RECORD OF DECISION

Tutu WellfieldSite

Anna's Retreat, St. Thomas , U.S. Virgin Islands

United States Environmental Protection Agency
Region II
New York, New York
July 1996

FIGURE 2

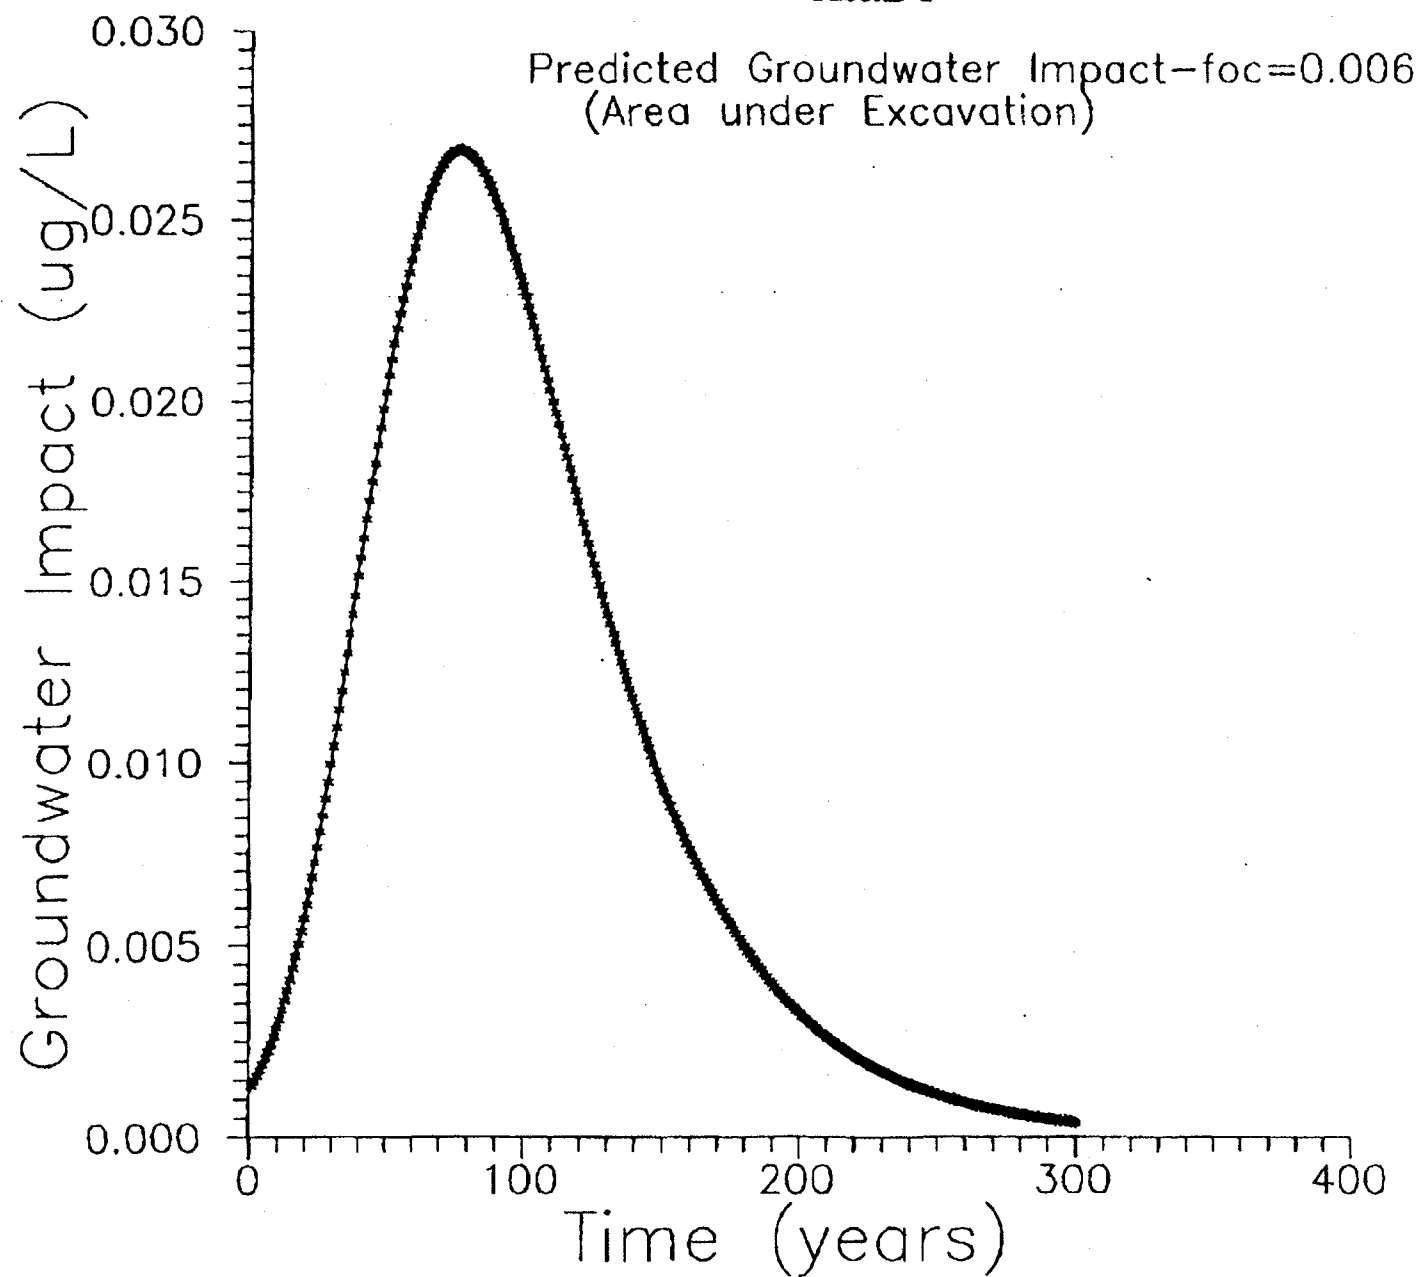
The incremental increase in PCE concentrations in groundwater for the O'Henry site using the two PCE concentration soil profiles are shown in Figures 1 and 2 respectively. Table 2 summarizes the highest groundwater PCE concentrations and the time at which the peak impact occurs beneath the site. Figures 1 and 2 show that with the current PCE soil concentration profiles, groundwater beneath the O'Henry site will not be impacted above EPA action limits. The site specific modeling will be incorporated into a new chapter titled, "Evaluation of Impact to Groundwater of Soils Left in Place."

Figure S-27

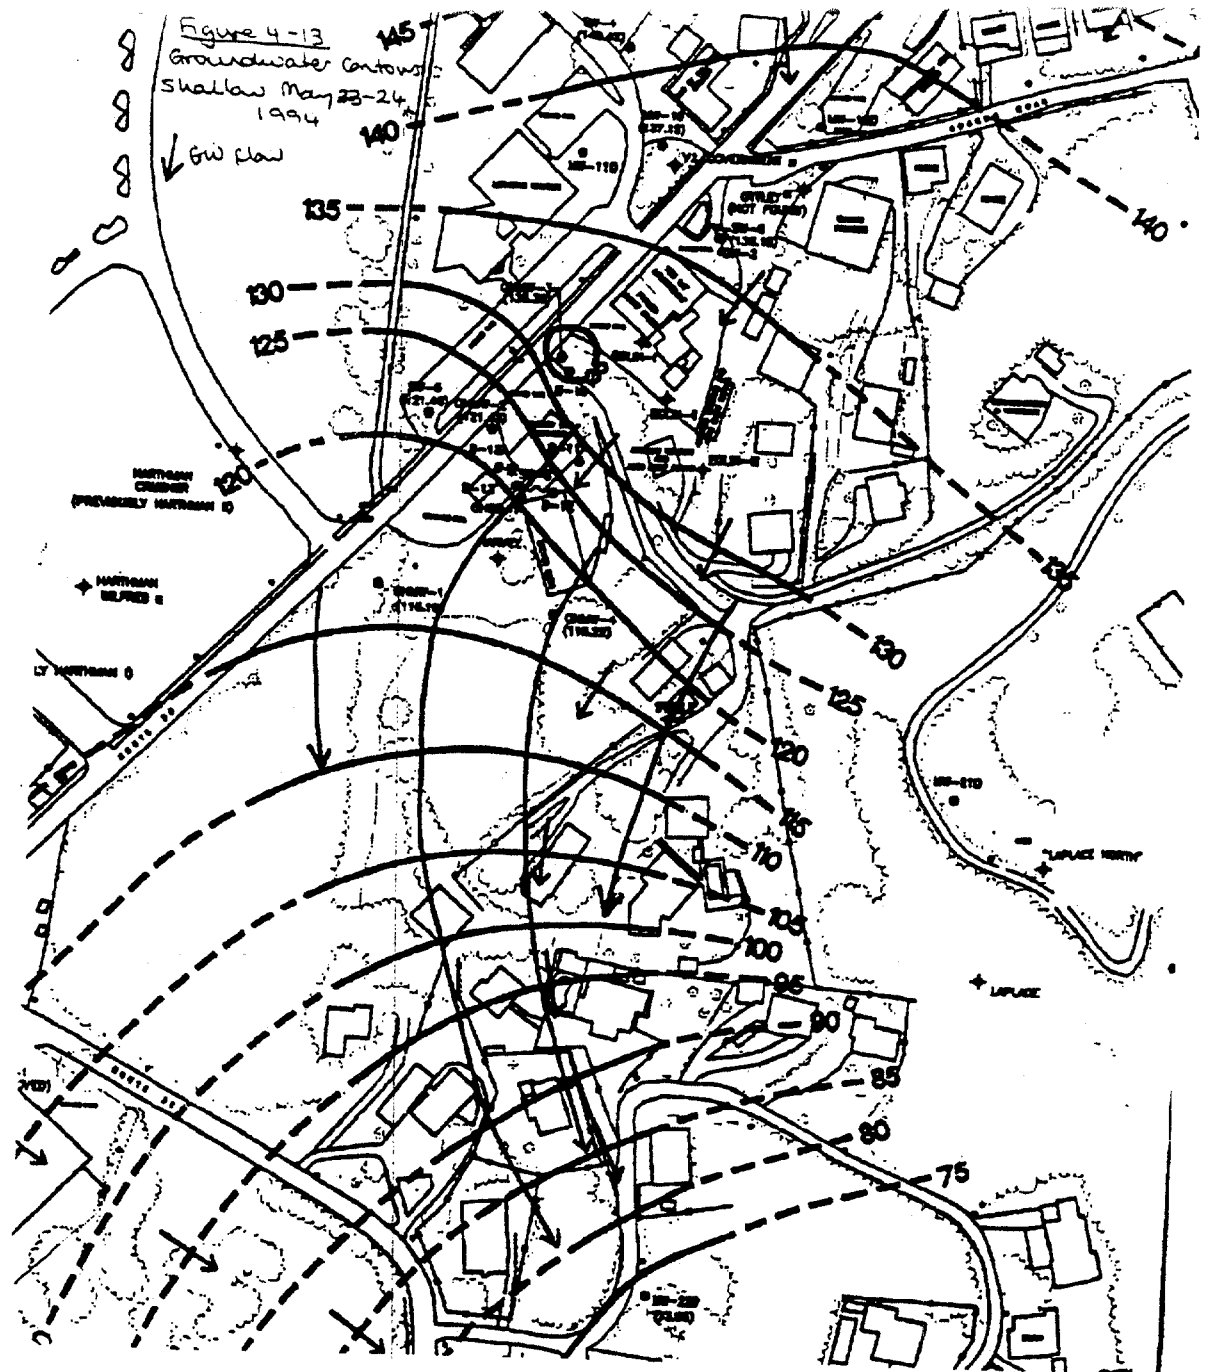
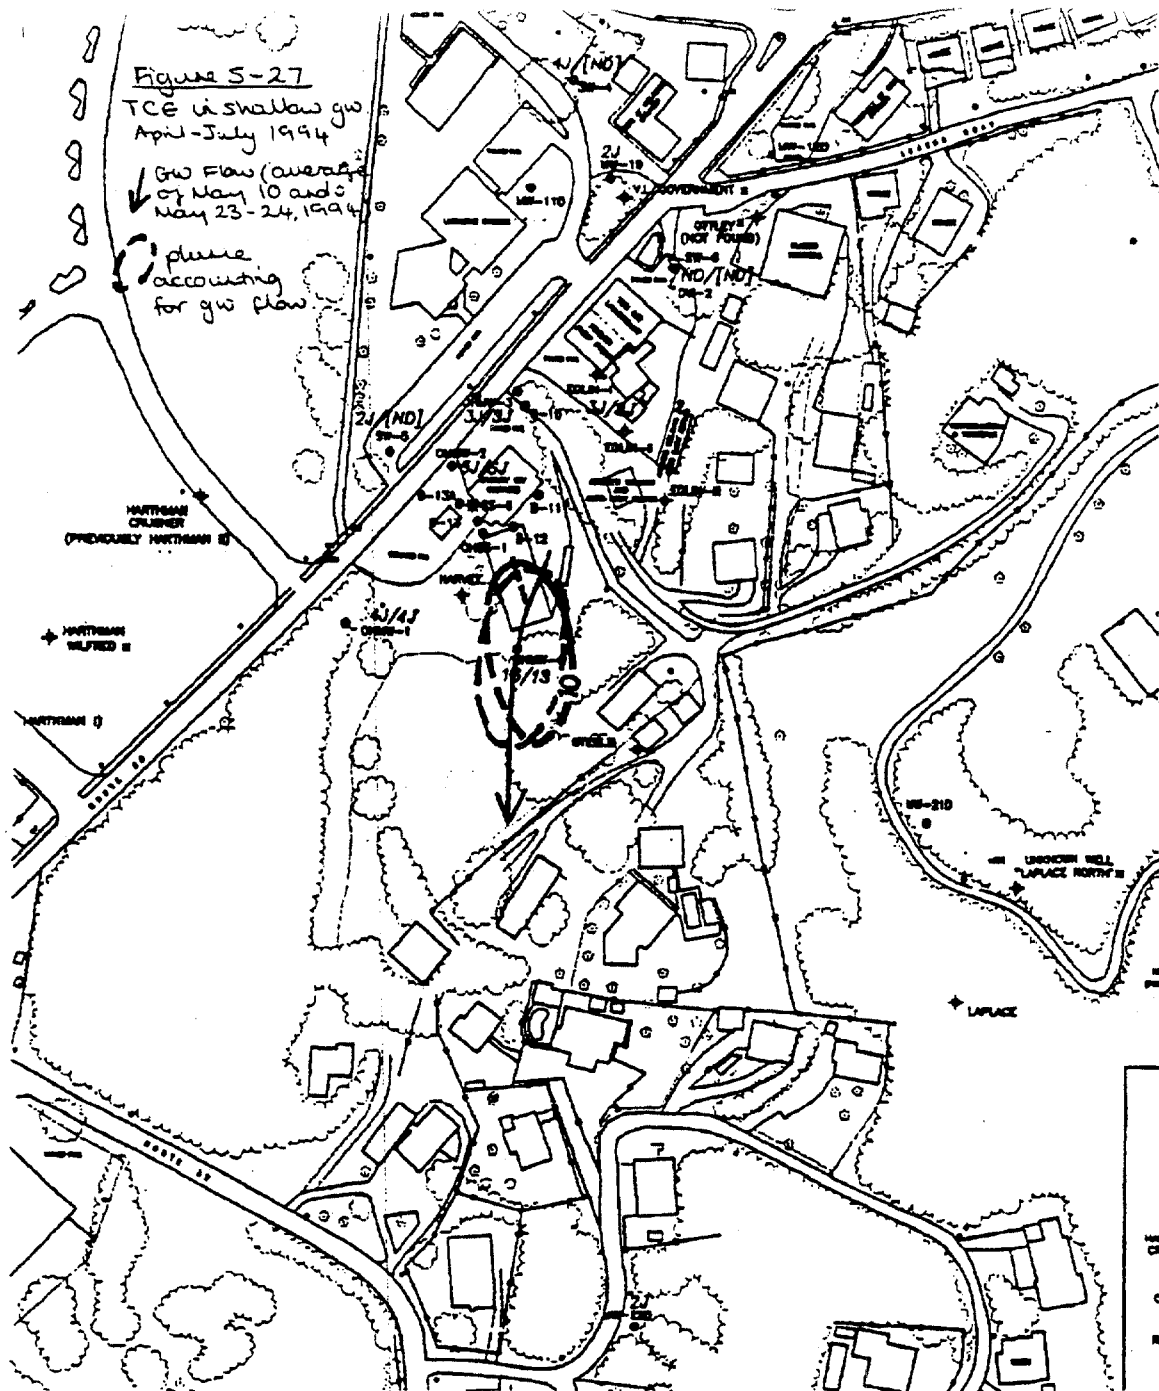
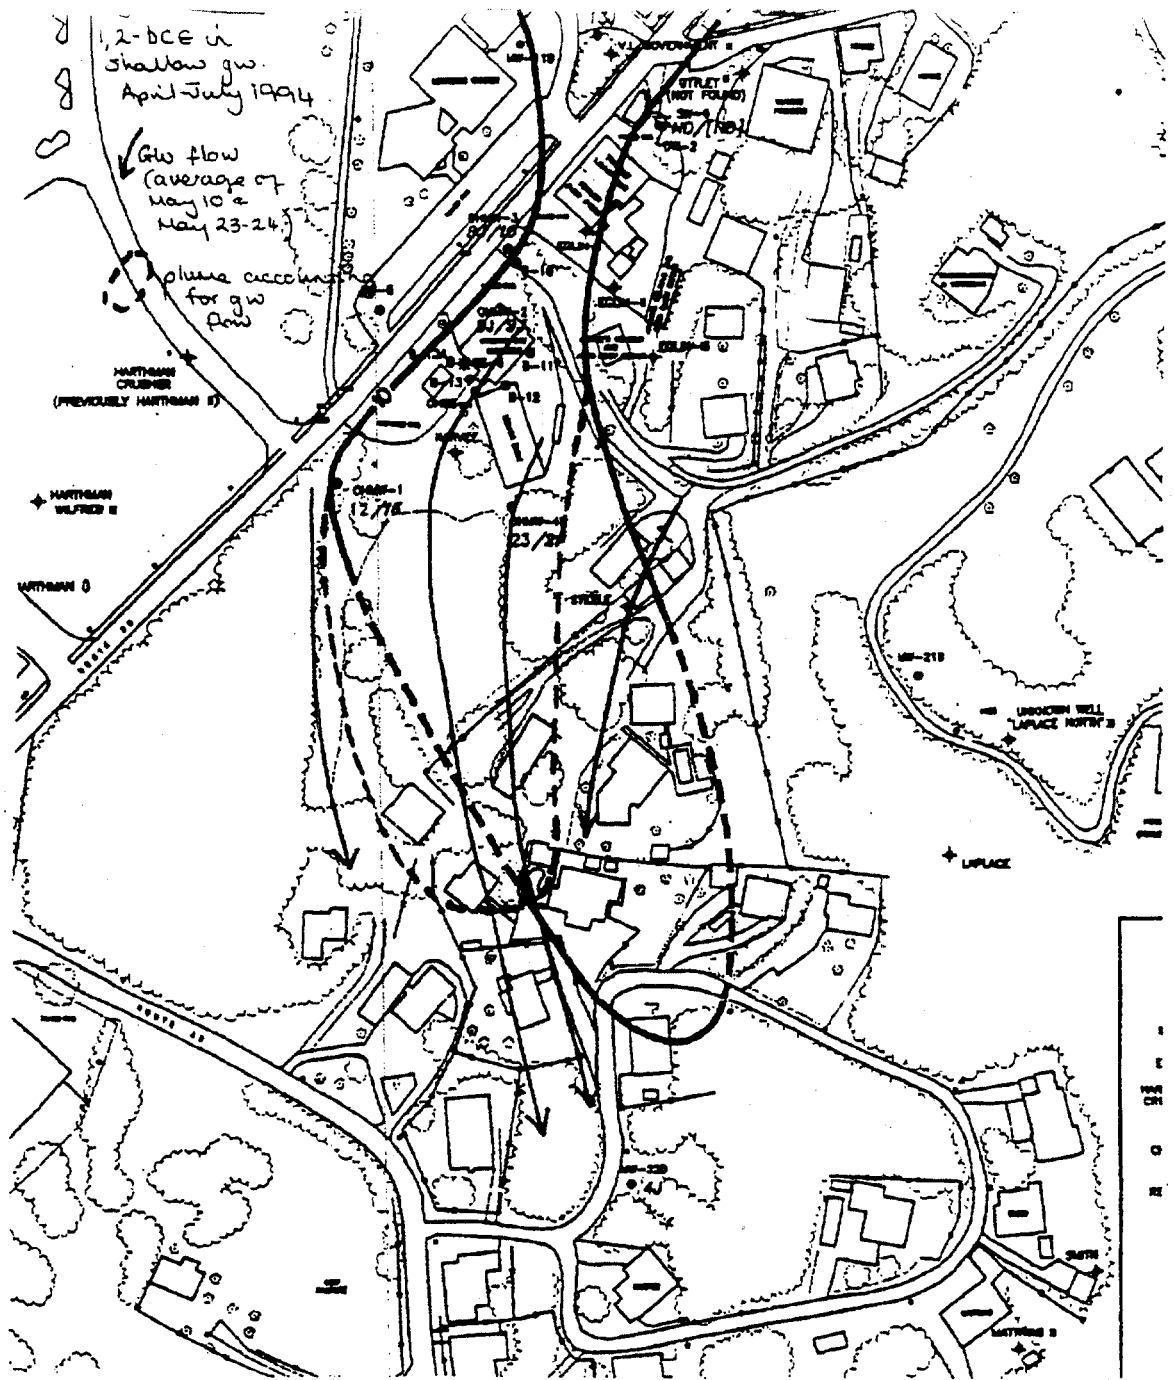
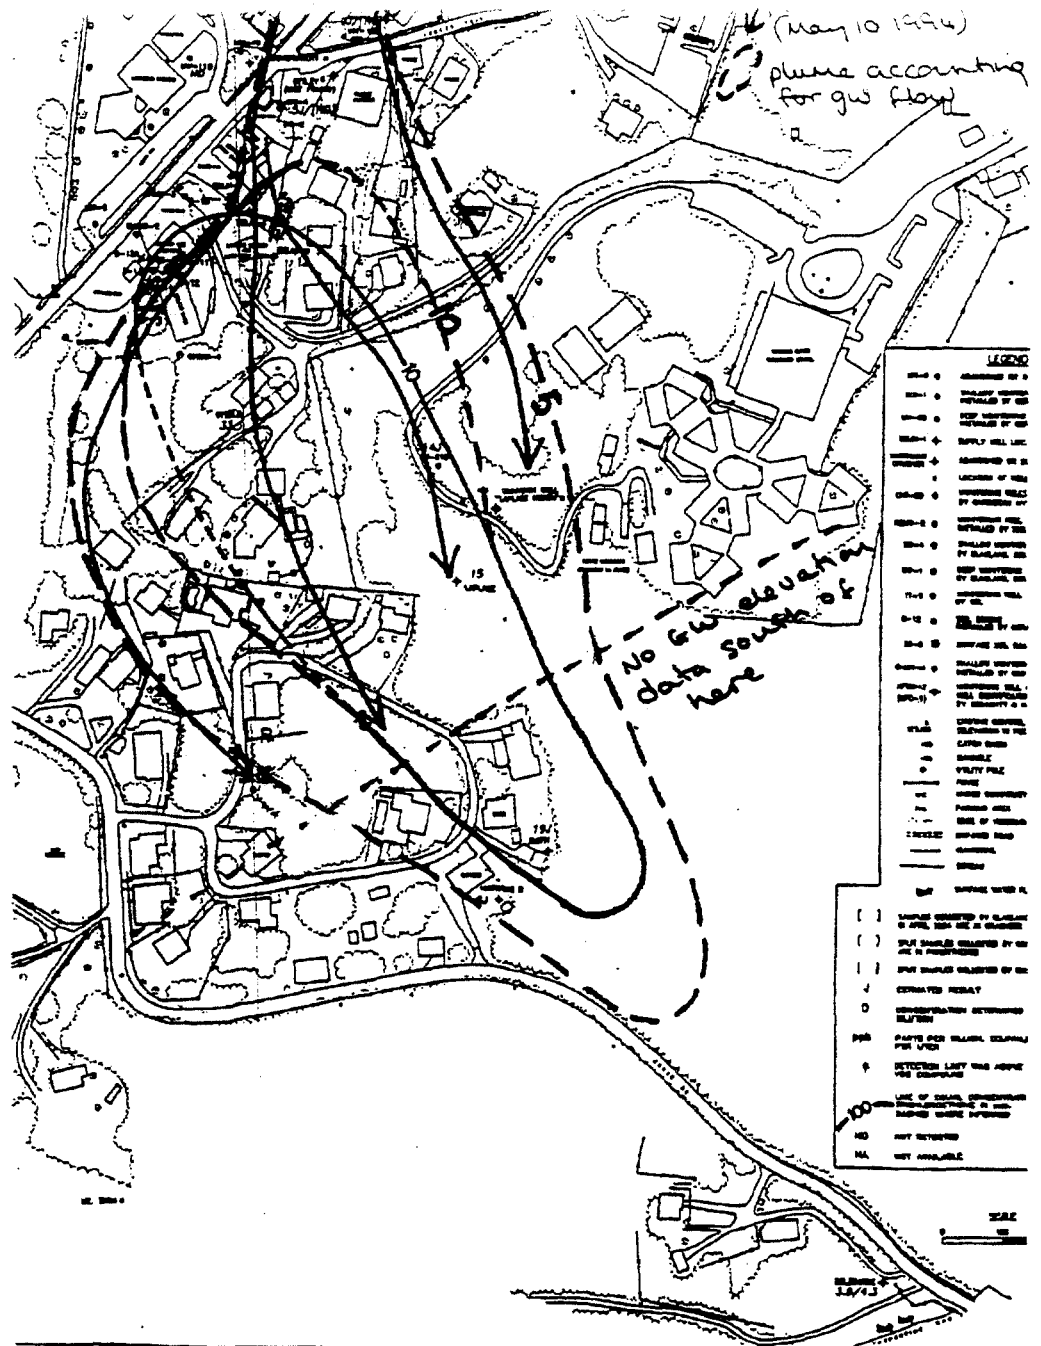
comment 1 above) for the deep groundwater (figure 4-14) as presented in the RI (figure 4-14). To develop more defensible plume maps for these compounds, flow lines were drawn on figure 4-14 (attached). Then flow lines were transferred to the plume maps and the plumes redrawn to take into account the flow directions (attached). The redrawn plume maps (which include a 5 ppb line for TCE) indicate similar patterns for the PCE, TCE and 1,2-DCE plumes, showing a wider plume in the area extending from the Eglin well to the LaPlace well as reflective of the divergent groundwater flow. Further it should be noted that no groundwater elevation data is available south of MW-22D therefore the plume is conjectural downgradient of that location.

The presentation of the TCE, PCE, AND 1,2 DCE in the deep groundwater is not consistent with the appropriate deep groundwater flow map as presented in the Report of the Remedial Investigation. A more consistent depiction of the plumes was submitted by IT with the comments on the Report of the Remedial Investigation. See, Exhibit 1, comment 2 and attached maps.
